## SUBMITTAL REVIEW

Submittal No.: 084113-002

Description: Aluminum Framed Entrances and Storefronts -SD

Project Name: UT SEAY Building Addition

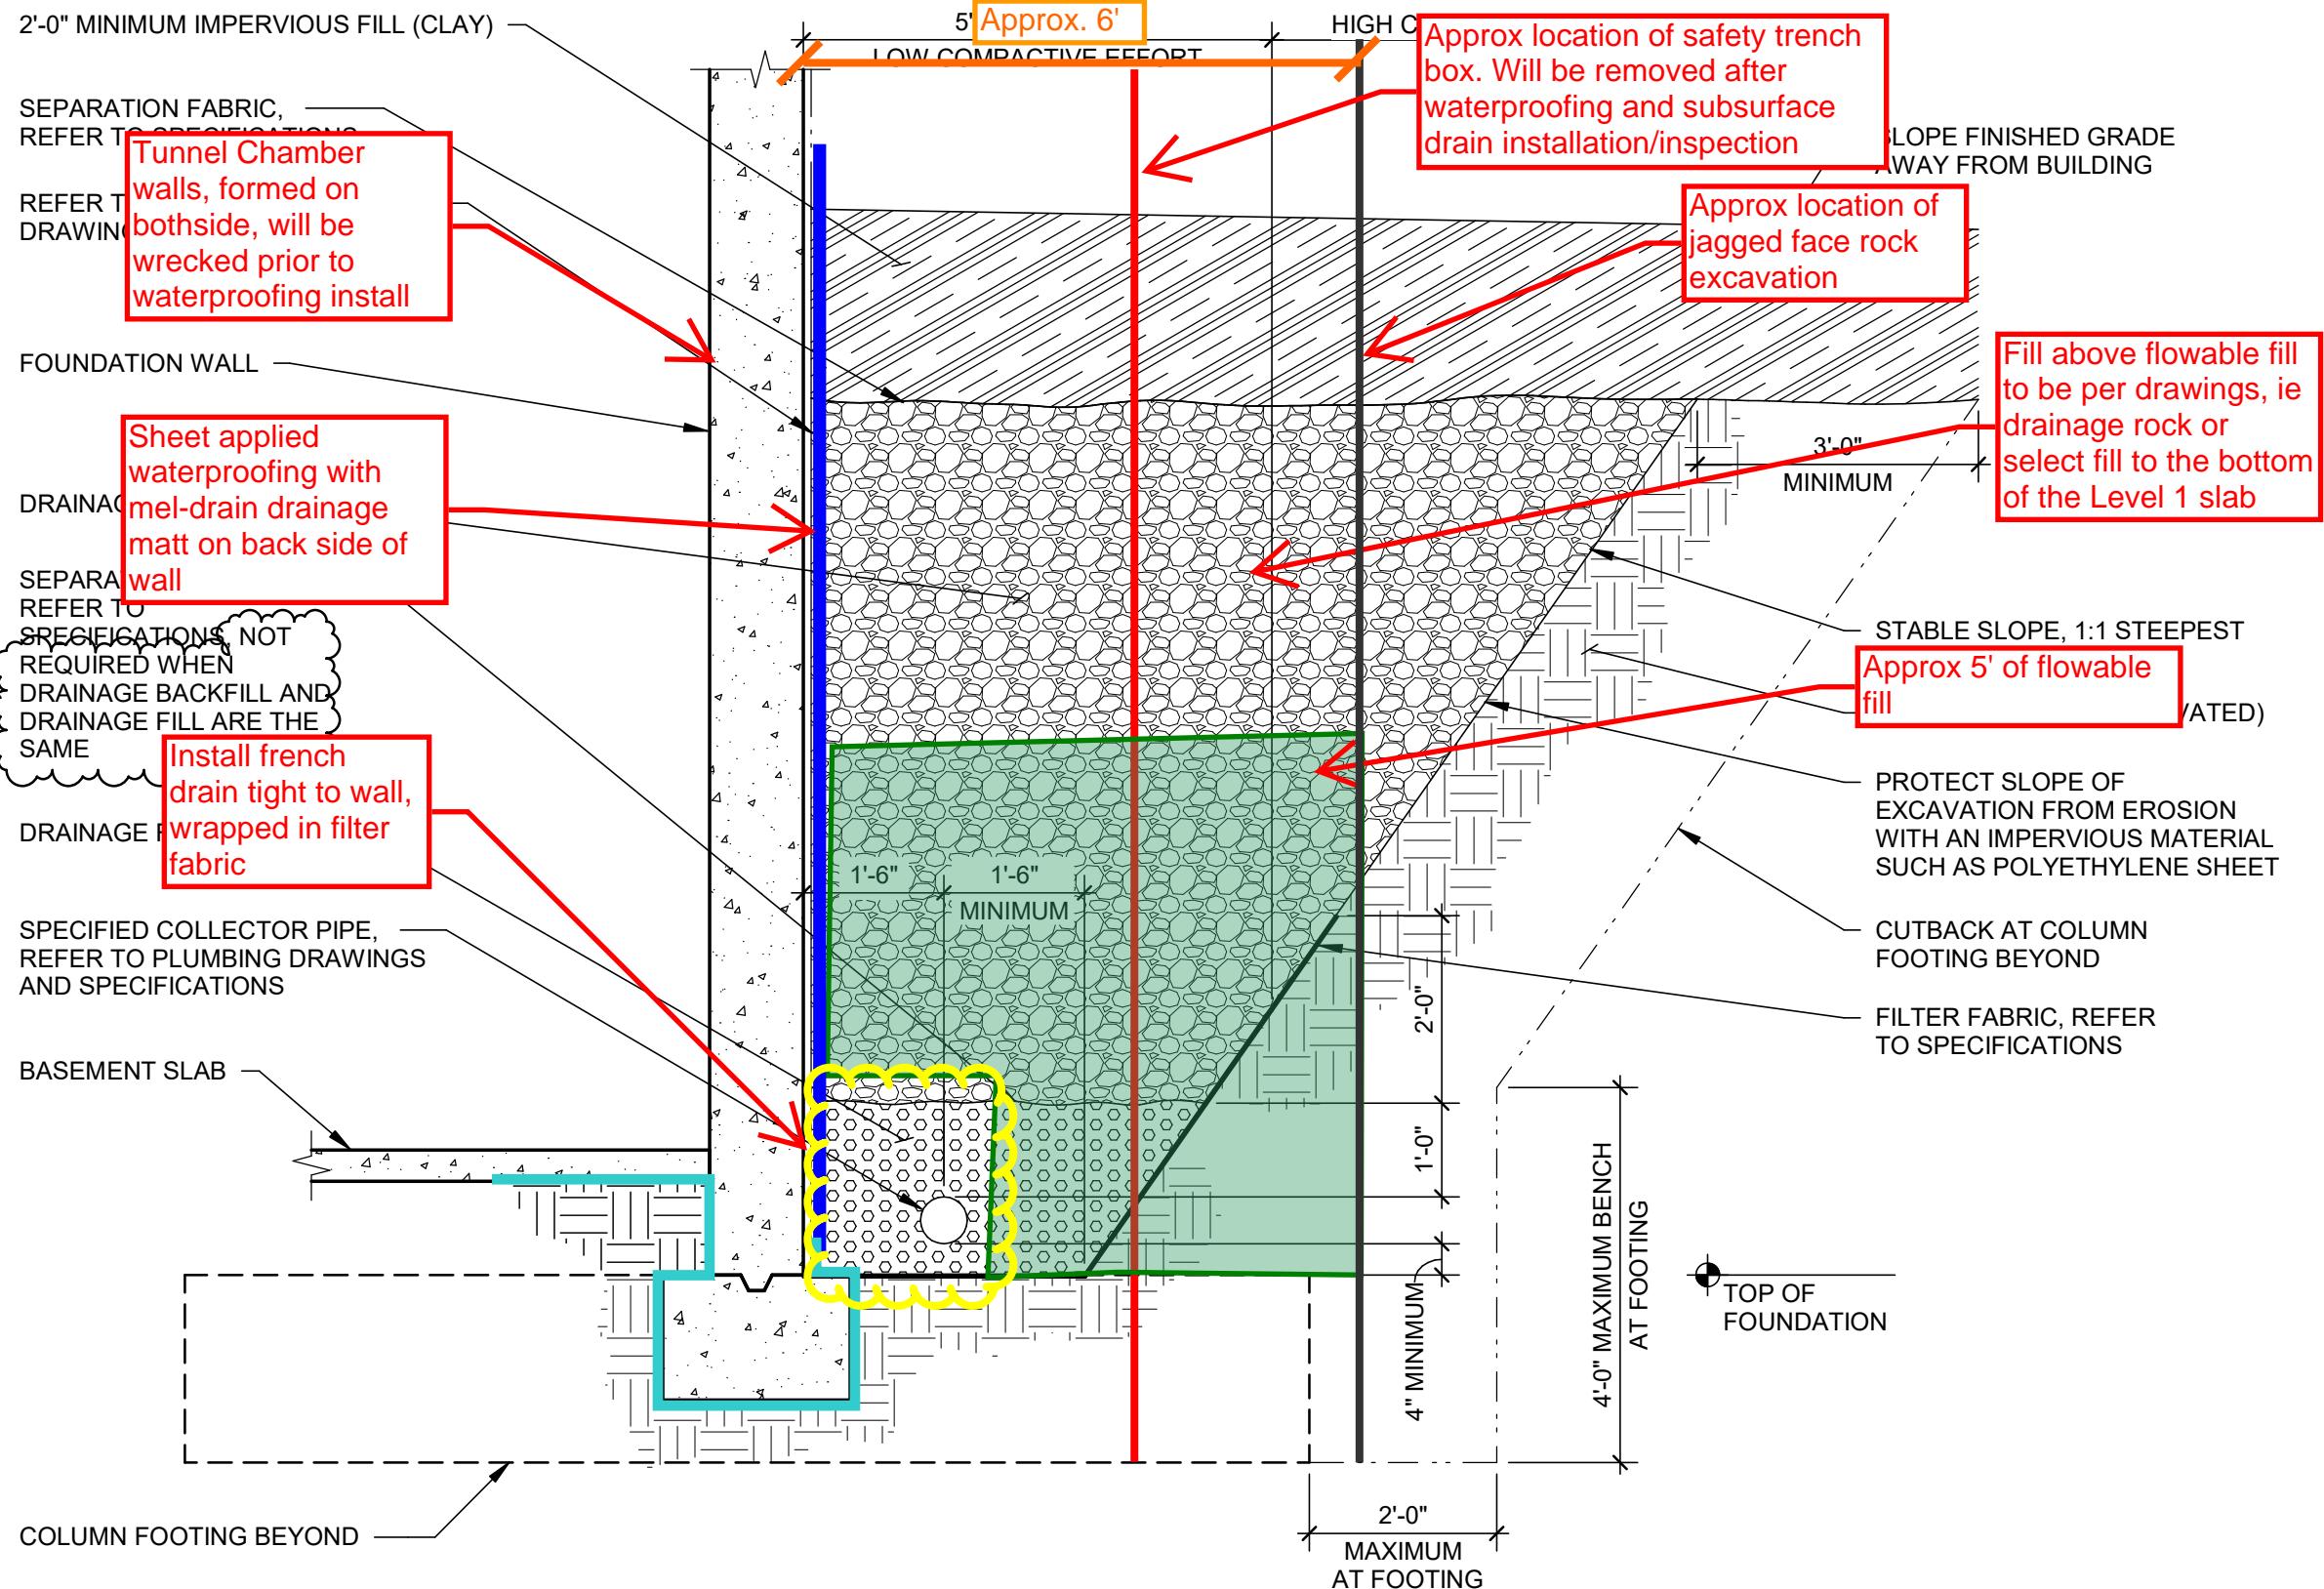
zsc recommends this is reviewed by the civil engineer to determine the functionality of the french drainage system if the fill material is changed. This will not have any affect on the waterproofing membrane as this material does not require a certain degree of compaction. However, we recommend the french drain remains fully operational to disperse ground water in a timely fashion. - daniel hodge 2020-06-11
